ADDENDUM NO. 2

REMEDIAL ACTION WORK PLAN

**53 PUTNAM STREET
SARATOGA SPRINGS, NEW YORK
BCP #C546057**

September 30, 2022

REMEDIAL DESIGN DOCUMENT SOIL EXCAVATION AND REMOVAL REMEDY 53 PUTNAM STREET PUTNAM RESOURCES, LLC CITY OF SARATOGA SPRINGS SARATOGA CO., NEW YORK
STERLING Sterling Environmental Engineering, P.C. 24 Wade Road • Latham, New York 12110
DATE: 10/05/2020 SCALE: 1" = 10' DWG. NO. 2015-30071 SHEET 2 OF 2

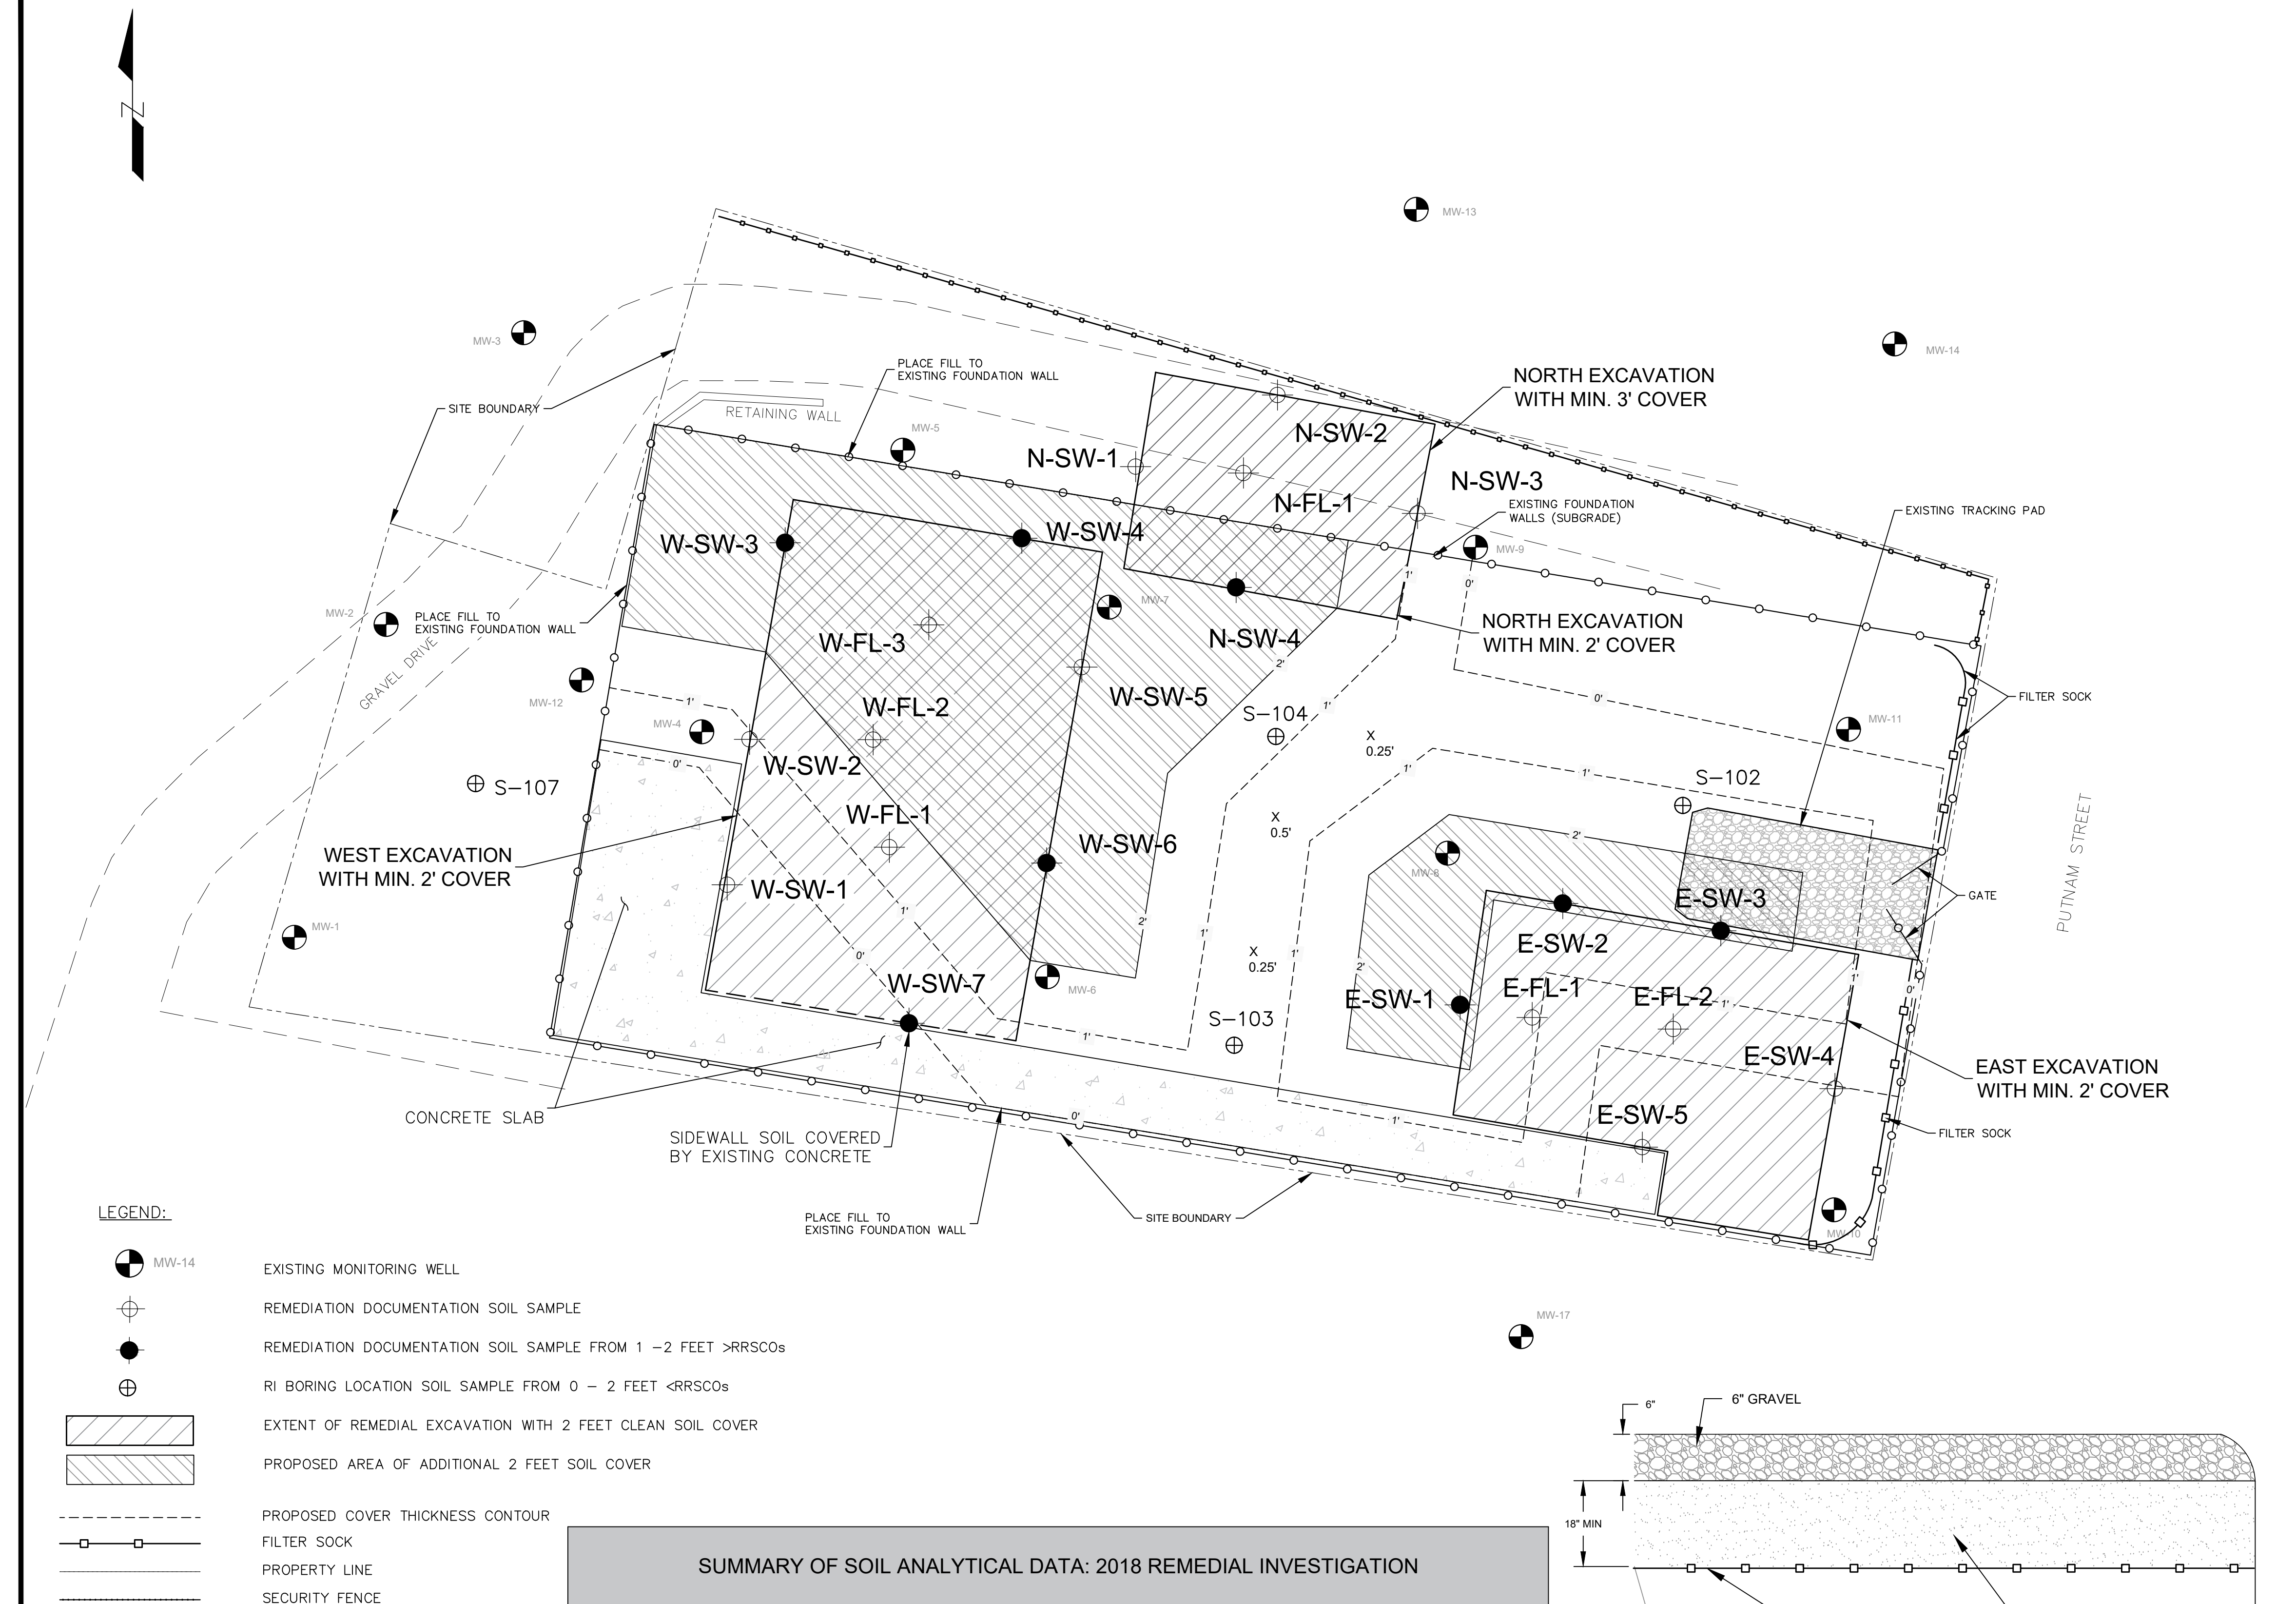
A minimum of two (2) feet of protective cover material will be placed over locations of documentation soil samples where concentrations of mercury are greater than RRUSCOs in the upper 2 feet of soil. The area for placement and the thickness of protective cover is shown in the Remedial Design Document (Attachment 1).

As shown in the Remedial Design Document (Attachment 1), soil cover will consist of a minimum of 2 feet of imported clean soil that meets the requirements of 6 NYCRR Part 375-6.7(d). Soil cover will be graded to ensure 2 feet of cover materials over the identified documentation samples and will be graded to taper and blend into the surrounding ground surface as shown by the thickness contours on the Remedial Design Document.

No excavation is proposed as part of this work. All cover system materials will be placed directly on the existing ground surface above a demarcation layer. The stabilized construction entrance remains in place from remedial construction and will be used to deliver materials to the site. As shown in Attachment 1, compost filter sock will be installed on the downgradient perimeter of the site to the north, east, and south of the stabilized construction entrance for erosion control. The placement of cover materials have been designed to smoothly transition to the surrounding existing ground surface to prevent ponding of stormwater or excessive flows that may contribute to erosion. The exposed surface of the cover system is proposed to be gravel, which has less erosion potential than sand backfill.

NO.	DATE	RECORD OF WORK	DRN	CKD	APPR
1	02/10/21	LABEL SITE BOUNDARY	TMJ	TMJ	AMM
2	09/16/22	REVISED COVER AREA PER RAMP ADDENDUM 2	PWS	TMJ	AMM
